Final reply to Referee 1's review of the AMTD paper

” Detailed characterisation of AVHRR global cloud detection performance of the CM SAF CLARA-A2 climate data record based on CALIPSO-CALIOP cloud information”

Karl-Göran Karlsson and Nina Håkansson, SMHI

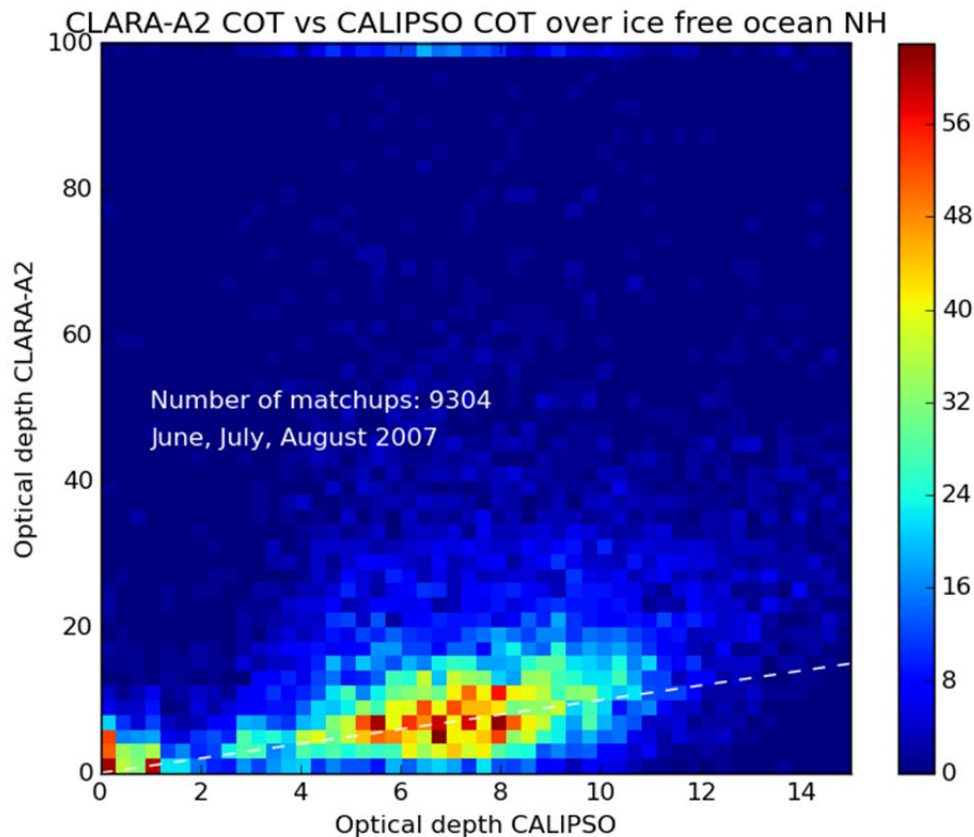
p5, l187: The optical thickness threshold of 5 for CALIPSO is higher than usually assumed. If it is necessary for this study to work with such a high threshold, it should be justified, and it should be explained how this is possible (referring to literature where this has been done, or with a dedicated sub-section in this manuscript where it is shown that the lidar does, in fact, allow to go to COD 5, and under which circumstances).

We admit that we do not have good support in the literature for stretching the useful upper limit of CALIPSO-derived COD to 5. However, in the description of the upgrade to CALIPSO-CALIOP version 4 it is also emphasized that previous cloud optical thicknesses in version 3 were generally underestimated. This is also clearly indicated in Figure 2 (new Figure 3) in the manuscript. Whether this increase entirely justifies moving the upper limit to 5 is still not clear.

We do have more indications from our own investigations that an adjustment of the upper limit seems possible. In a study related to a paper by Riihelä et al (2017) we investigated the correlation between CALIPSO-estimated and CLARA-A2 estimated CODs over various surfaces (with snow surfaces over Greenland as the main target). However, when isolating the collocated results over ice free ocean surfaces at high latitudes (noting that over a dark surface also the AVHRR-based estimations should be more accurate), we could clearly see a

good correlation between the two estimations up to about COD=5 (see figure below):

Although this is not a perfect illustration (not included in Riihelä et al, 2017, but maybe considered for a follow-up paper) it shows how CLARA-A2-estimated optical depths compare to CALIOP-estimated optical depths in the range 0-15. Over a dark ocean surface the majority of values agree pretty well but what is clear is that an increasing number of cases (for higher optical depths) CLARA-A2 values saturates at 100 for CALIOP-values exceeding approximately 4 (noticeable at top of the figure). This reflects the inability of CALIOP to provide reasonable optical thicknesses for optically thick clouds. But, we made the conclusion that values compare pretty well even up to an optical thickness of 4-5 and this was one of the reasons why we decided to use the CALIOP interval 0-5 for this particular study (for AMT).

It is this finding that made us to use the maximum limit of 5 in this particular study. Unfortunately, in the end, we did not include this part of the inter-comparison in the finally published paper by Riihelä et al. (2017).

We propose that we keep the original maximum value of 5 in our plots but add a remark that values near this upper end are uncertain (lines 146-154). The upper

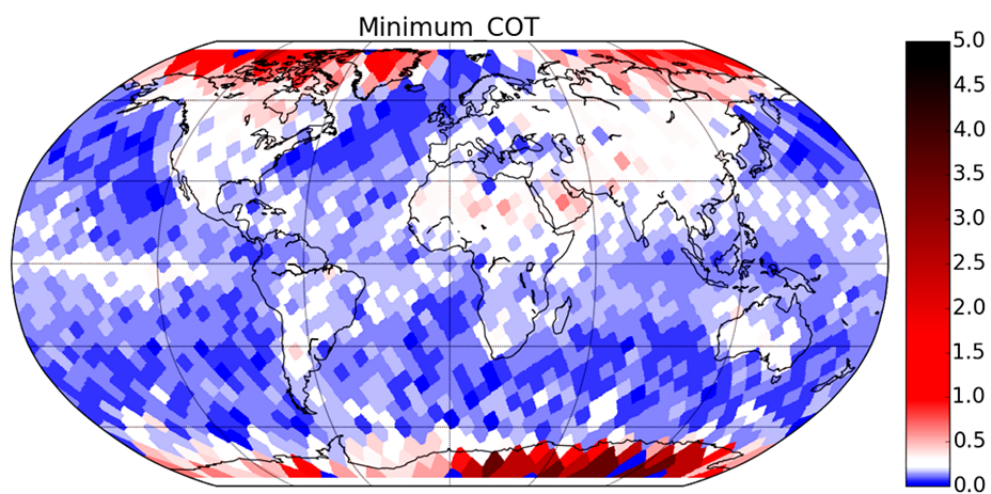
p9,l355-359: Add explanation why AVHRR gives higher cloud cover. It is easy to imagine a scenario where small cumulus clouds would be picked up by AVHRR (even if below its spatial resolution), but not by CALIOP products (for physical reasons). The statistical explanation given here does not seem to be complete and is hard to follow.

However, the results in Figure 7 (new Figure 8) illustrate a more general problem. One has to remember that all results in Figures 6-10 (new Figures 7-11) are based on comparison with a CALIOP cloud mask filtered at cloud optical thickness 0.225 (the latter being the global mean cloud detection sensitivity). But regionally, the value of the cloud detection sensitivity varies a lot (see Figure 11 or new Figure 12). We have also changed the colour scheme in Figure 11 (new Figure 12) so that the relation to the mean value of 0.225 is made clearer:

In the new Figure 12 all values below the mean value 0.225 are plotted in blue colours and values above 0.225 in red colours. This colour representation also indicates better the highest values in the polar areas (not properly visualized in the old Figure 11).

Notice here that most oceanic areas are coloured blue and that the positive bias in Figure 7 (new Figure 8) is also mostly occurring over oceanic areas. By using a CALIOP cloud mask with cloud optical thickness being cut at 0.225 as our validation reference, we are then ignoring a substantial fraction of originally detected clouds below this cloud optical thickness limit over ocean surfaces. But these clouds are to a large extent actually detected in the CLARA-A2 results. Thus, it leads to an apparent (but largely false) overestimation of cloudiness over ocean in Figure 7 (new Figure 8 - notice that we are filtering CALIOP data and not CLARA-A2 data). We have added a discussion of this aspect in the Discussion section (lines 627-640).
